SUPPLEMENTARY NOTICE OF SIGNALLING ALTERATIONS ETC.  
SECTION 'C' OF THE K2/37/73 SPEED AND ENGINEERING NOTICE  
BETWEEN SATURDAY 15 SEPTEMBER AND WEDNESDAY 19 SEPTEMBER - WORCESTER SHRUB HILL  
STATION RESIGNALLING (STAGE 1)

# WORCESTER SHRUB HILL STATION

## RESIGNALLING STAGE 1

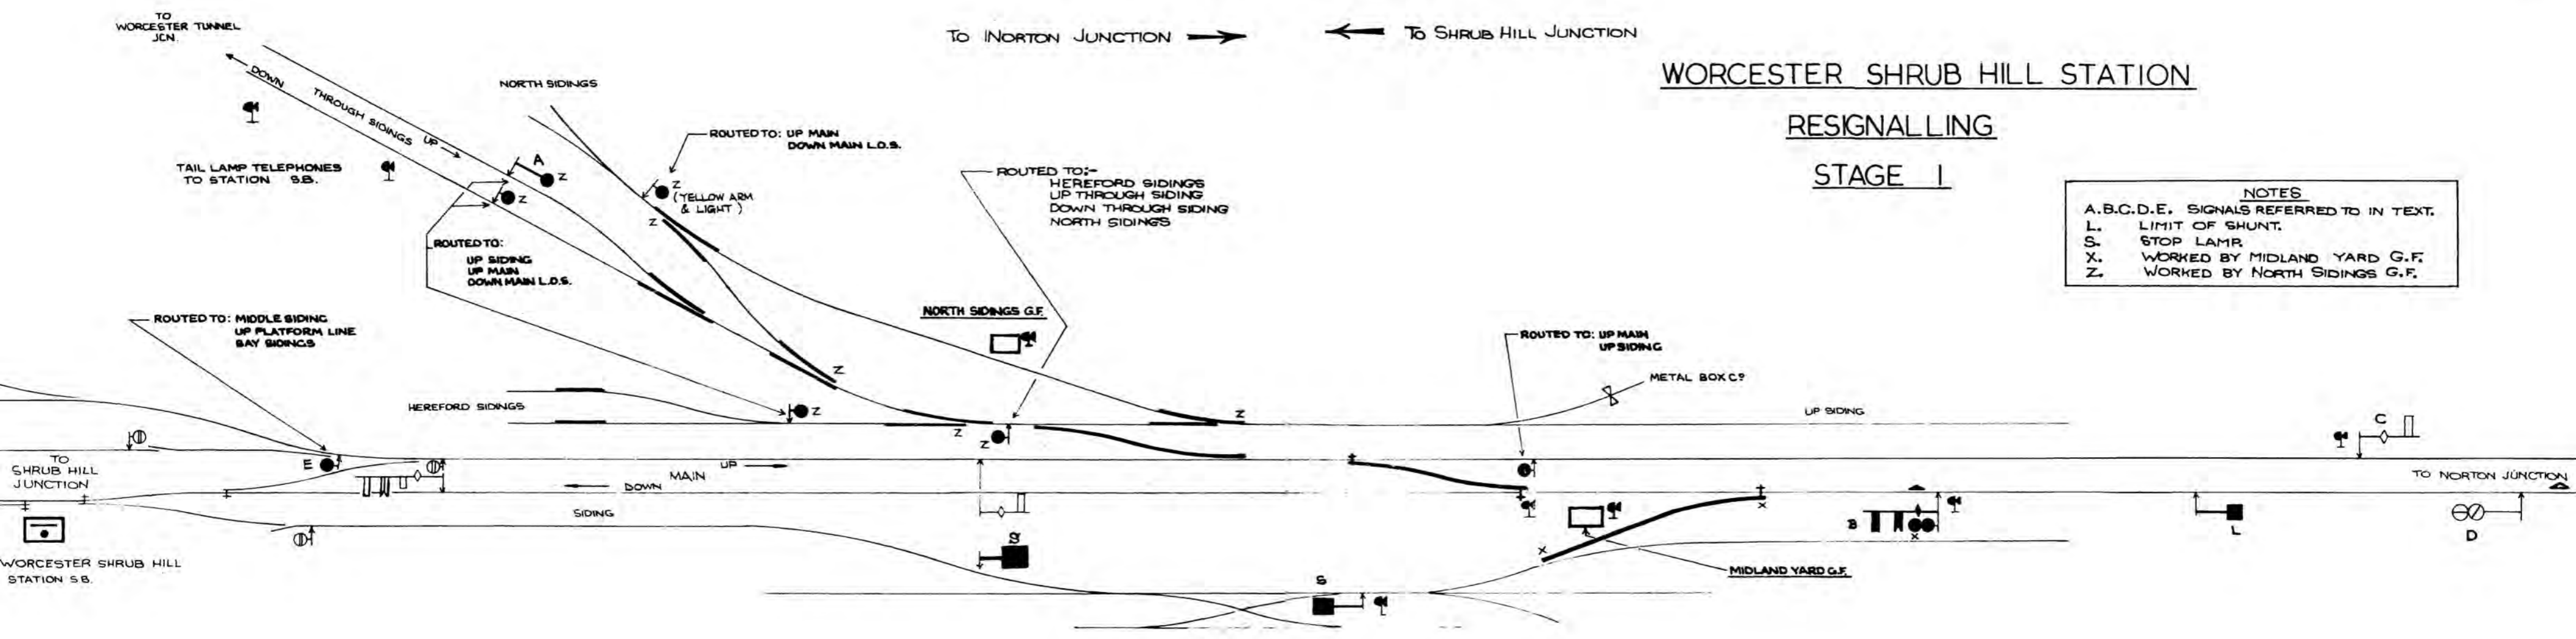
Between the hours of 22.00 on Saturday 15 September and 18.00 on Wednesday 19 September 1973, or until completion, the Chief Signal & Telecommunications Engineer will be engaged in introducing Stage 1 of the Worcester Shrub Hill Resignalling Scheme in accordance with the attached diagram.

The new connections as shown on the diagram will be brought into use. The catch points in the Hereford Sidings exit to the Up Siding (120m. 20½ch.) will be replaced by plain line.

Wylde Lane Junction Signal Box and all associated signalling equipment will be recovered, with the exception of the Up Main Starting and Down Main Distant Signals.

New signals and ground Discs worked from Worcester Shrub Hill Station will be brought into use as shown on the diagram. The description of the signals is as follows :-

<u>Description</u>	<u>Position</u>	<u>Distance from signal box</u>
A	Up Through Sidings (elevated Disc) to Up Siding or Up Main or Down Main Limit of Shunt	Up side of Up Through Siding	Distance from Shrub Hill Station Signal Box 240 yds.
This signal will be 18 feet above rail level.			
B	Down Main Home lower arm Distant Down Main Home to Midland Yard (top Disc) or to Up Main or Siding (bottom Disc)	Down side of Down Main	Distance from Shrub Hill Station Signal Box 585 yds.
The height of the Home signal will be 22 feet above rail level.

<u>Existing</u>	<u>New</u>
C	(Wylde Lane) Up Main Starting	Up Main Advanced Starting
D	(Wylde Lane) Down Main Distant	Down Main Distant.

The slot release on the Up Main Starting signal from Wylde Lane will be recovered.

The Disc backing Up Platform Line, the double Disc backing Up Main to Up Platform Line or Middle Siding and the double Disc backing Up Main to Up Platform Line or Bay or Bay Siding will be recovered and the new Disc (E) shown on the diagram will be released by Worcester Shrub Hill Junction Acceptance lever when routed to the Up Platform Line.

The existing double Disc at the Shrub Hill Junction end of the Middle Siding will be replaced by a single Disc exhibiting a yellow arm and light routed to the Down Platform Line.

Midland Yard Ground Frame, controlling points, facing point lock and signal shown 'X' on diagram, released from Shrub Hill Station Signal Box by Annetts Key.

North Sidings Ground Frame, controlling points and signals shown 'Z' on diagram, released from Shrub Hill Station Signal box by interlocking levers.

The Stop lamp nearest Worcester Tunnel Junction on the Up Through Siding will be repositioned approximately 100 yards nearer Worcester Tunnel Junction and the second Stop lamp on the Up Through Siding will be recovered.

A Stop lamp will be provided from the North Siding at the fouling point with the Up Through Siding.

Those points shown as new on the accompanying diagram and not operated by Ground Frames will be operated by point machines of the electro-hydraulic clamp lock type. Special keys for emergency operation of these points will be located in sealed boxes in Worcester Shrub Hill Station Signal Box.
